Leeds Bradford Airport Airspace Change

Respecting the Leeds Bradford Airport Airspace Change Proposal which appeared on the CAA website on 18th January 2019, we request that this application be called in for review by the Secretary of State on the grounds that one aspect of the proposals is likely to result in a net increase of more than 10,000 people becoming subject to aircraft noise in excess of 54 Db $L_{Aeq 16hr}$.

Figure 1: LBA's Diagrammatic Representation of Continuous Ascent Profiles

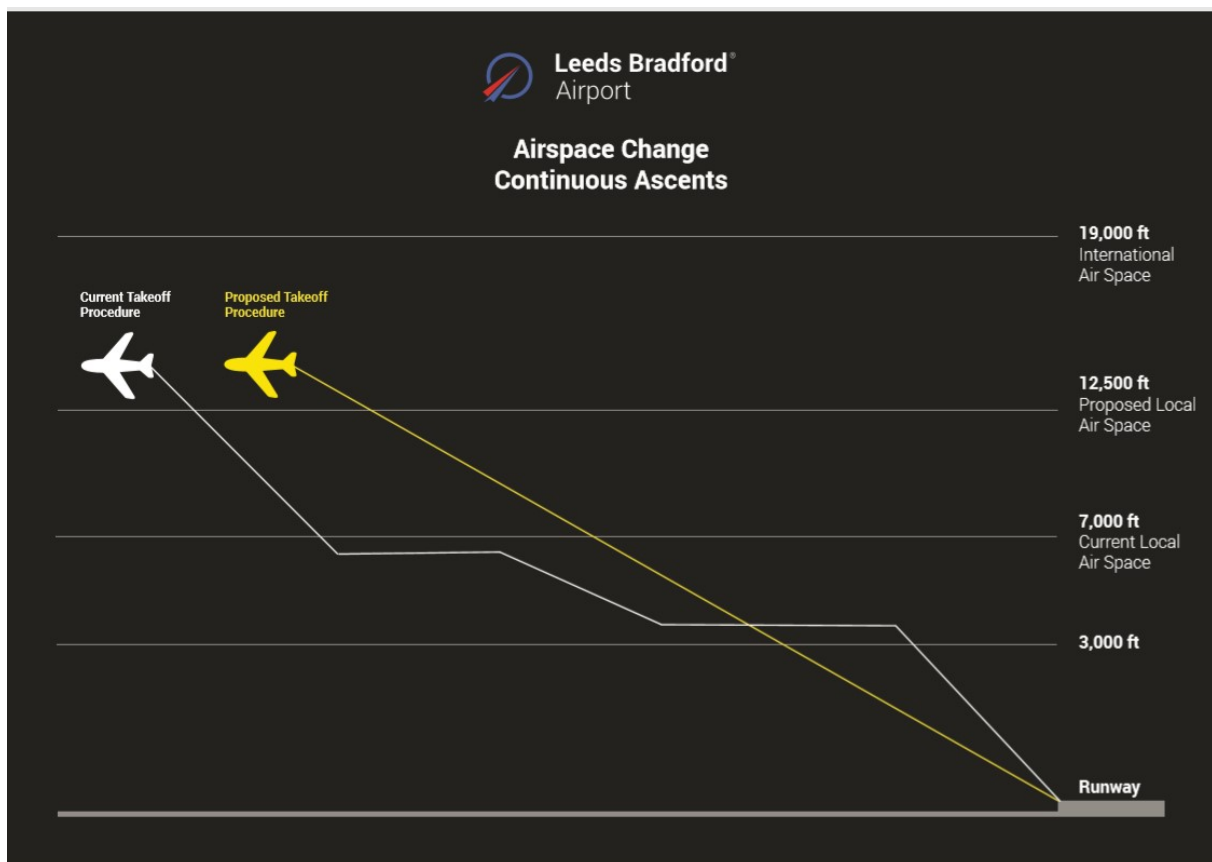
Figure 2 shows the area to the southeast of the airport and includes the current $L_{Aeq 16hr}$ contours as estimated in LBA's Consultation Addendum. The blue zone shows is the area which we think will be brought within the 54Db $L_{Aeq 16hr}$ contour if aircraft take off more gradually as per Figure 1. We have estimated the extent of the blue zone based on our understanding that aircraft currently reach 3000 feet near waypoint NME01³. NME01 is 11352 feet from the end of the runway and so we have assumed that the $L_{Aeq 16hr}$ values currently experienced around and beyond NME01 would, with shallower climbs, be experienced at and beyond 22704 feet from the end of the runway (i.e. in the vicinity of Burley Park rail station).

We are well aware that our estimate of the blue zone in our Figure 2 is unlikely to be accurate, but we believe it to be the best estimate available in the public domain. We are aware that LBA have, since submitting their proposal to CAA, stated that Figure 1 is misleading (although it, together with its accompanying text, was produced and circulated by them as part of the consultation process). However, they have not disowned it in writing nor have they produced a replacement diagram, nor do any of their documents state that the new ascent paths will NOT be shallower than they are currently. We therefore think it prudent to submit this call-in request.
